NRC DOCKET NUMBERS 50-424 AND 50-425
CONSTRUCTION PERMIT NUMBERS CPPR-108 AND CPPR-109
VOGTLE ELECTRIC GENERATING PLANT - UNITS 1 AND 2
SER CONFIRMATORY ITEM 44: PROCEDURES GENERATION PACKAGE

In the SER your staff requested to review the VEGP EOP's deviations from the ERGs. Enclosed are the deviations noted in our review along with the appropriate justifications.

| APPROVAL <i>W. F. Kitchens</i> | Georgia Power POWER GENERATION DEPARTMENT VOGTLE ELECTRIC GENERATING PLANT |  | PROCEDURE NO. 11894-C |

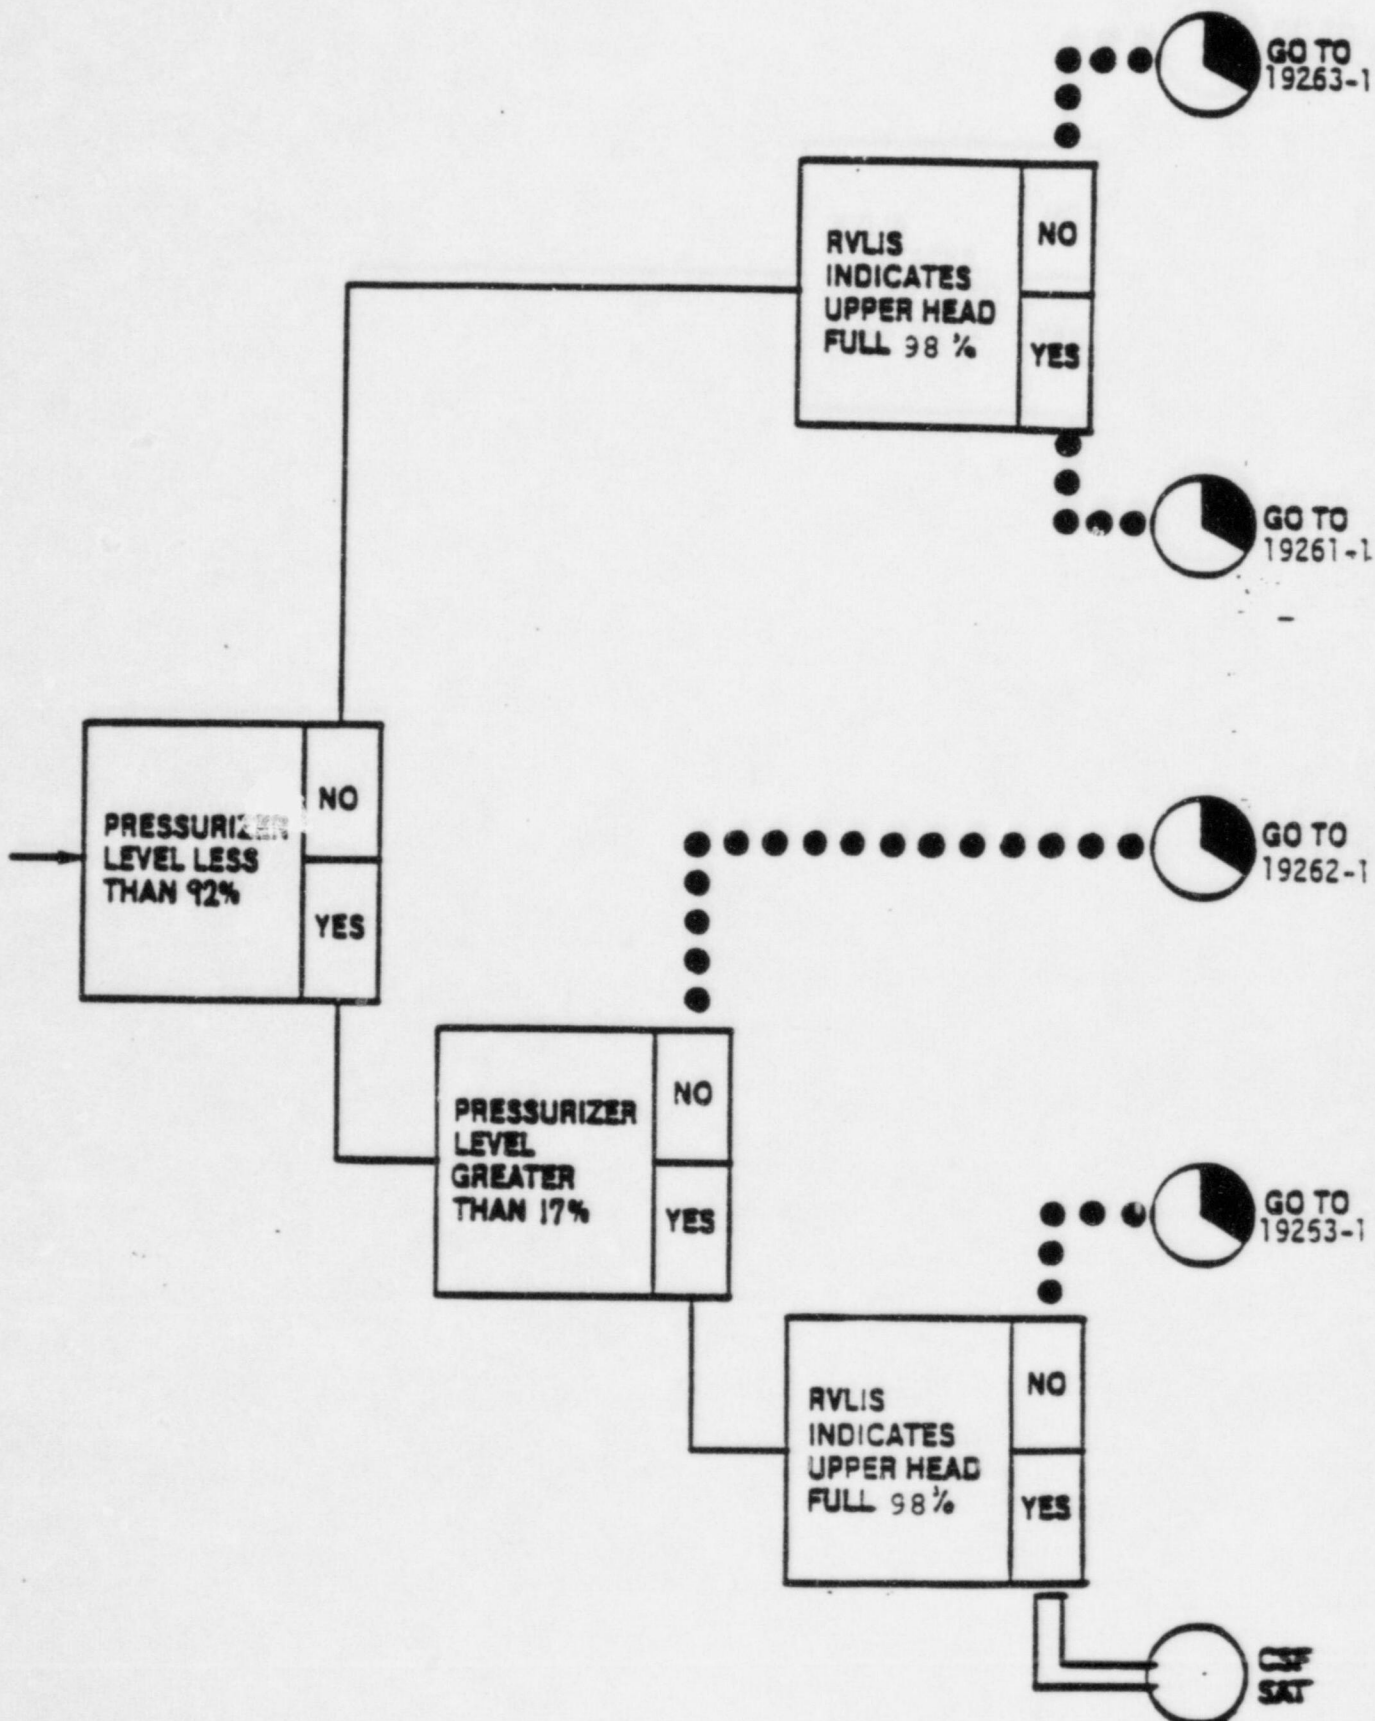
Plant specific
values and VEGP EOP
identification was included.
